STATE OF NEW YORK  
OFFICE OF THE ATTORNEY GENERAL

Re: Indian Point Nuclear Generating Station, Unit 2 and Unit 3  
Docket ID NRC-2008-0672  
Docket Nos. 50-247-LR/50-286-LR

In accordance with the notice published in the December 29, 2015 edition of the Federal Register, enclosed please find comments submitted by the State of New York Office of the Attorney General concerning the NRC Staff Draft Supplemental Environmental Impact Statement, Draft Report for Comment, Second Supplement – Vol. 5 (December 2015). 80 Fed. Reg. 81,377-78.

**Figure 10 Comparison of annual PGA exceedance frequencies for U.S. PWR and BWR Mark III reactors (USGS 2008 model)**

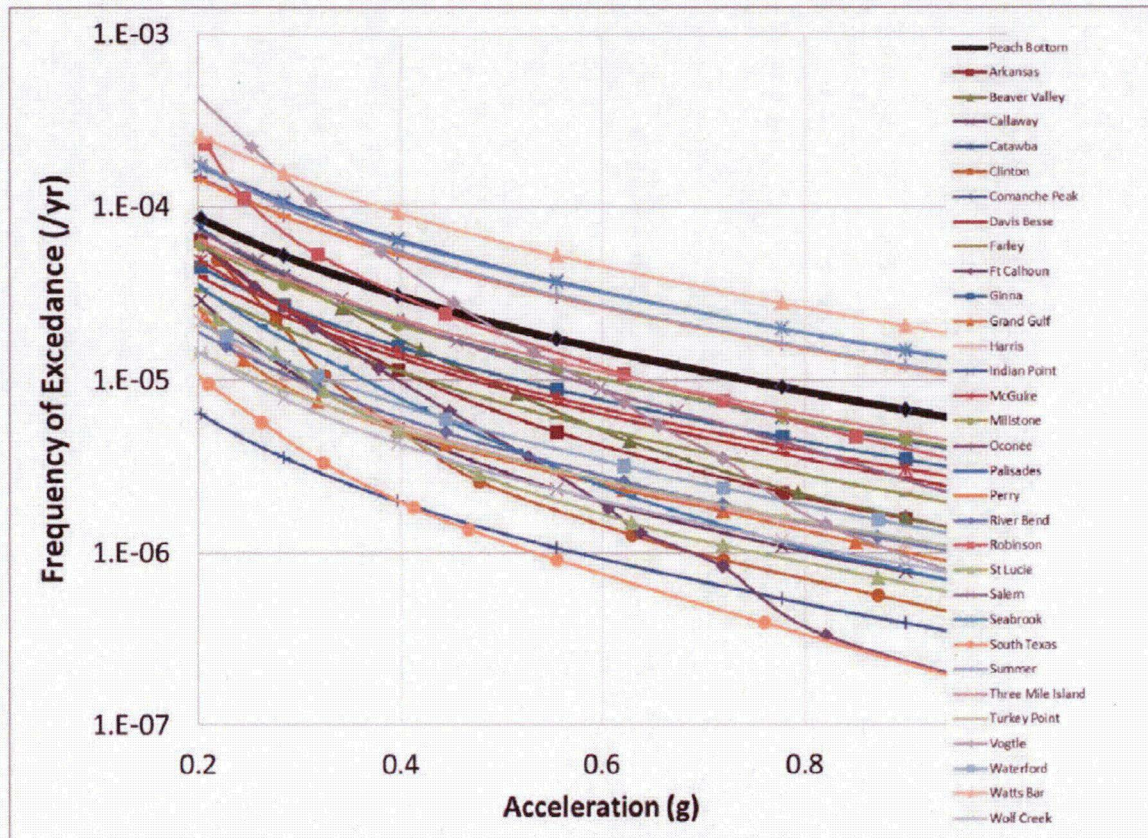
although the actual frequency of exceeding 1.2 g at Indian Point is not quoted in the GEIS or NUREG-1738, the data shown in Figure 10 of COMSECY-2013-0030 (p.81, reproduced below) suggests that this frequency is greater than  $2 \times 10^{-6}$  per year. See figure below:

Moreover, the data in COMSECY-2013-0030 may be underestimating the frequency because it does not account for new seismic hazards recently discovered at Indian Point. Since the probability of a pool fire at Indian Point is likely higher than the probability considered in the GEIS, the GEIS does not analyze the risk of a pool fire at Indian Point.

Figure: Effect of Storage Rack Configuration on Heatup of PWR Spent Fuel, Well-Ventilated Room. Source: 1979 Sandia Report at 51.

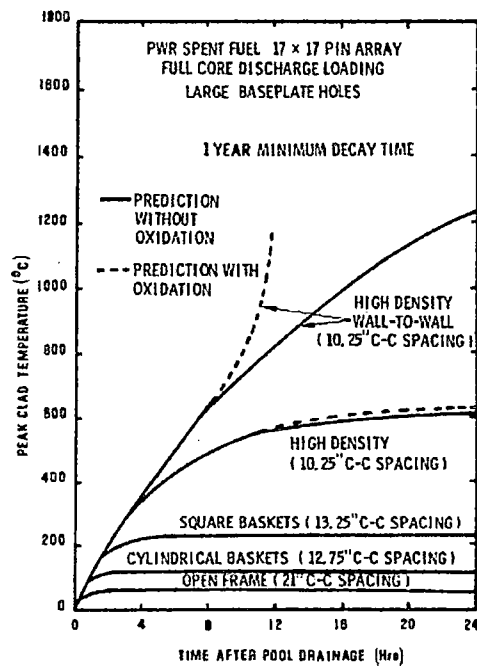
One alternative that should be considered is the thinning of spent fuel pools. Densely packed spent fuel heats up faster in the event of the loss of cooling water than sparsely packed fuel,<sup>34</sup> giving workers and emergency crews less time to respond to prevent fire or other damage to the fuel assemblies.<sup>35</sup>

**Figure 2:** Removal of one fifth of the spent-fuel assemblies could result in every fuel assembly having one side exposed to an empty channel.

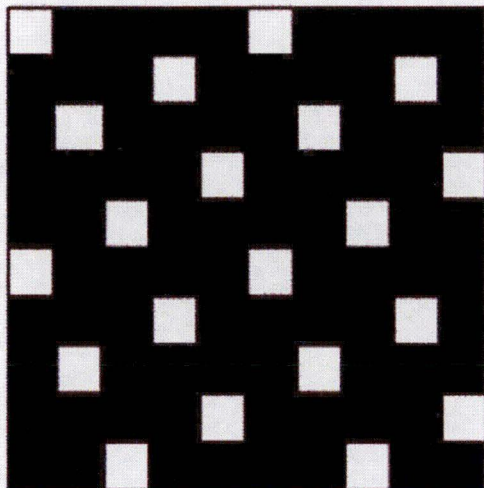
arrangement where alternate rows of fuel assemblies are removed from the rack.”<sup>45</sup> The first suggestion is illustrated in the figure below.<sup>46</sup>

Similarly, a report by the National Academy of Sciences recommended that, space permitting, empty slots be arranged throughout the pool to promote natural air convection in the event that the pool is completely drained.<sup>47</sup> That report also found that spent fuel is less at risk from accident or attack in dry cask storage than in a fuel pool.<sup>48</sup> This is because the spent fuel stored in dry casks has been cooled for at least five years, and is therefore, not prone to zirconium cladding fires.<sup>49</sup> Moreover, the dry cask system divides the spent fuel between many different casks—each cask stores only 10 to 15 tons of fuel, as opposed to a pool, which stores

**Figure 2: Population and wind rose for the Indian Point site. LEFT - Population by grid element (darker colors represent higher population) (ML13073A555 at p. 2-7), RIGHT – Wind rose for years 1999-2002 (ML12334A743).**

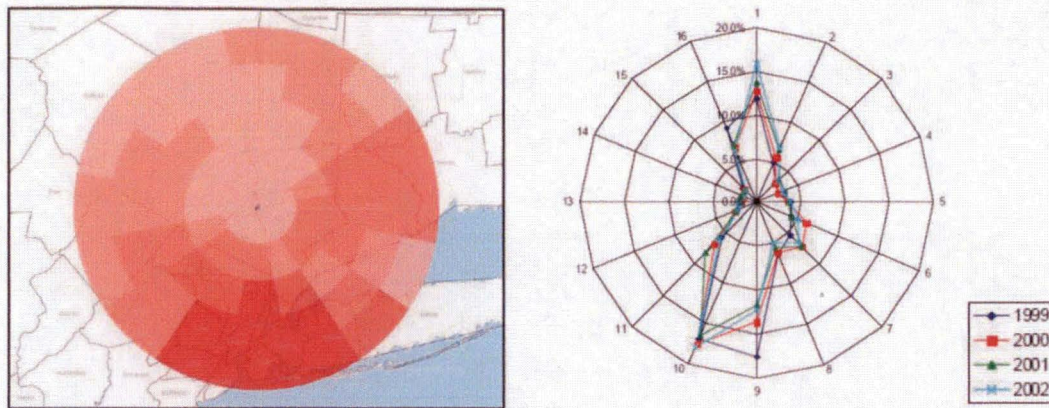
The wind rose (i.e., probability of wind directions) of the site has a direct correlation to the probability of certain areas being contaminated in the event of a severe accident and thus requiring mitigative actions. In the Consequence Study, the reference plant Peach Bottom's wind rose was such that the predominant wind directions were towards lower population areas (US-NRC 2013b, Section A.2). By comparison, the predominant wind directions at the Indian Point site are to the North/North-Northwest and to the South; the latter would affect the New York City metropolitan area, one of the most populated areas in the U.S (see Figure 2 below, showing the highest population concentrations surrounding Indian Point and the wind rose).

Because many plants are located in low population areas, Peach Bottom's population may be representative of some plants. Given the combination of Indian Point's population and predominate wind direction, the results of US-NRC's Peach Bottom analysis are not applicable to Indian Point. As shown in Figure 3 below, the population density within 50 miles of the Indian Point site is far greater than even those considered in the Consequence Study's sensitivity analysis.<sup>7</sup> With the combination of higher population and a dominant wind direction toward the most populated areas, it is reasonable to expect that the consequences to the public surrounding Indian Point may
